SUBJECT: Forwards responses to NRC 810521 request for addl info re: auxiliary feedwater sys automatic initiation & flow indication. Four oversize drawings encl. Aperture cards will be available in PDR.

Re: St. Lucie Unit #1
Docket No. 50-335
Auxiliary Feedwater System
Automatic Initiation and Flow Indication

REQUEST FOR ADDITIONAL INFORMATION

ST. LUCIE 1 AUXILIARY FEEDWATER (AFW) AUTOMATIC
INITIATION AND FLOW INDICATION

Figure 1
AFAS LOGIC

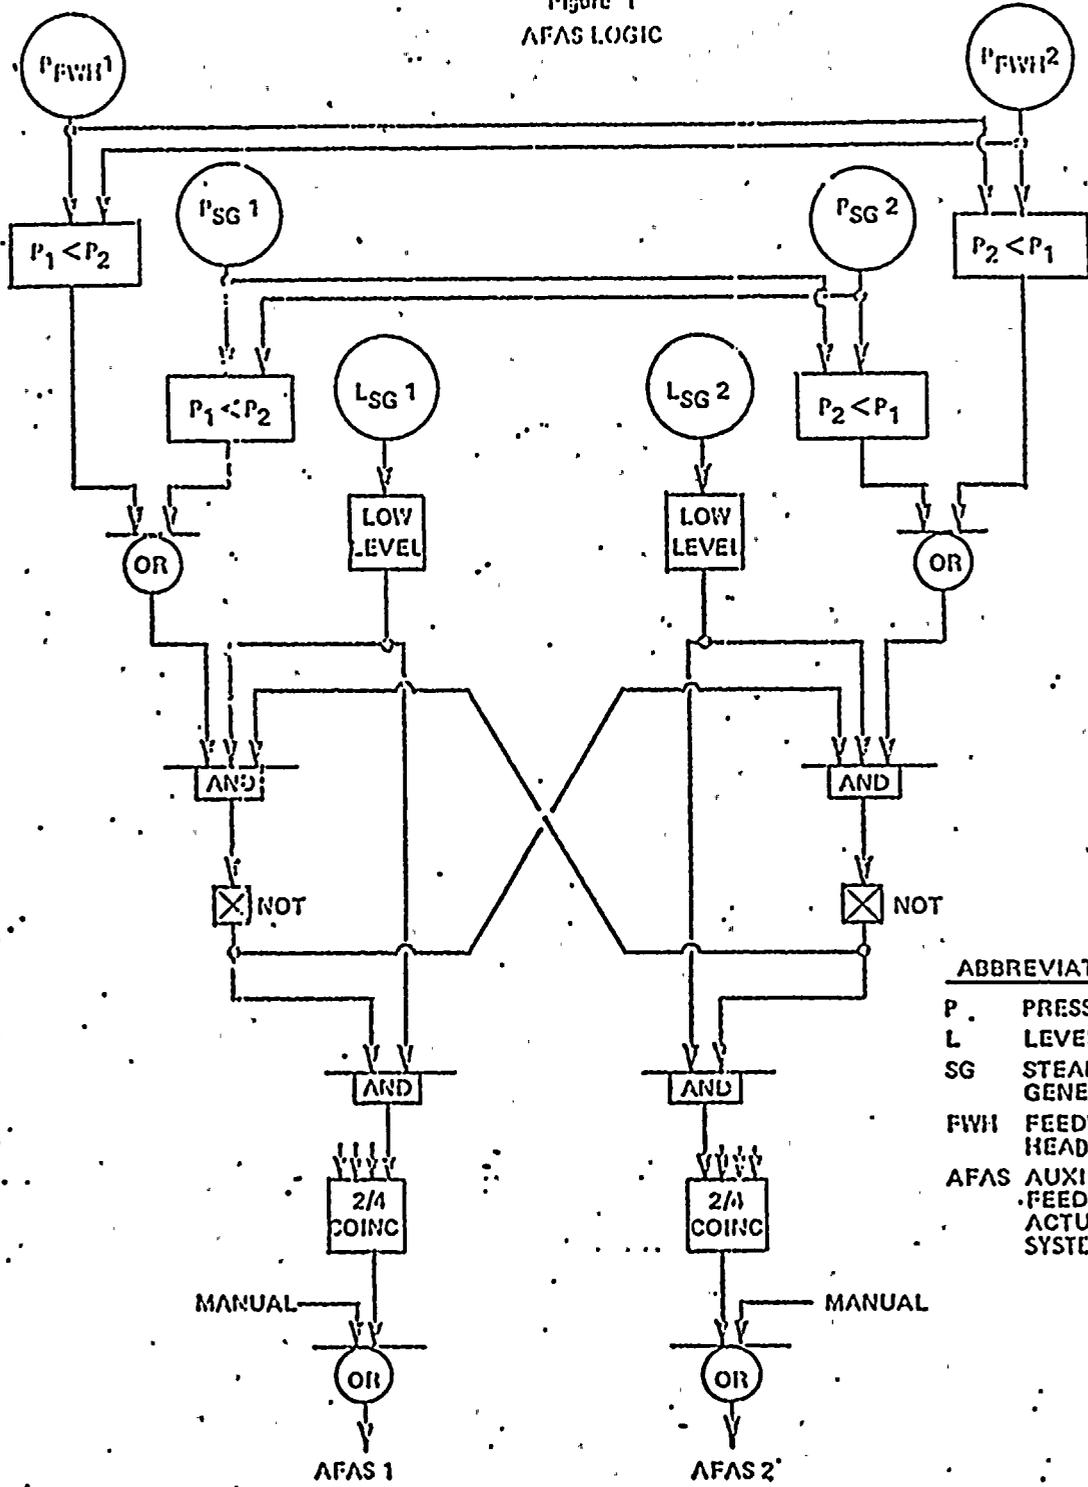
By Florida Power and Light (FP&L) letter dated January 2, 1981 (L-81-4), Enclosure 2, it is stated that "The AFWS will automatically terminate auxiliary feedwater flow to a faulted steam generator and automatically provide auxiliary feedwater flow to the intact steam generator." Provide a detailed description of this feature (i.e., automatic termination of AFW to the faulted steam generator) including logic and schematic electrical diagrams.

The auxiliary feedwater actuation system automatically initiates auxiliary feedwater to the intact steam generator upon demand and terminates or prevents auxiliary feedwater to the steam generator identified as being ruptured. The AFAS is a four channel IE system that provides separate feedwater initiation signals for each steam generator (identified as AFAS-1 and AFAS-2). Both signals are provided in each channel to interface with the individual components (pumps, valves).

The logic which is used within each channel to define feedwater initiation or termination is shown in figure 1. AFAS is initiated within each channel upon receipt of a low S.G. water level signal provided the steam generator or associated feedwater header is not identified as being ruptured. A rupture signal is generated upon the following conditions:

- S. G. pressure is approximately 100 psi below the other S.G.; or
- Feedwater supply header pressure is approximately 100 psi below the other feedwater supply header pressure; and
- Its associated S.G. is identified as having a low water level, and
- The other S.G. or feedwater header is not identified as being ruptured.

The logic discussed above produces a digital (on/off) signal within each channel for AFAS 1 and 2. These signals are combined across the four channels to form a two-out-of-four logic. This logic produces an AFAS 1 or 2 actuation signal within each channel to control the pumps or valves associated with that signal. Therefore, initiation of AFAS 1 or 2 will cause the final AFAS actuation relays to deenergize thereby energizing

the associated pumps and valves to provide feedwater to the appropriate S.G. Should the S.G. be identified as being ruptured, the AFAS actuation relays would reenergize (except pump actuation relays) and close the associated valves. For further detail of the above project, see CE drawing E-00000-411-801 (attached).
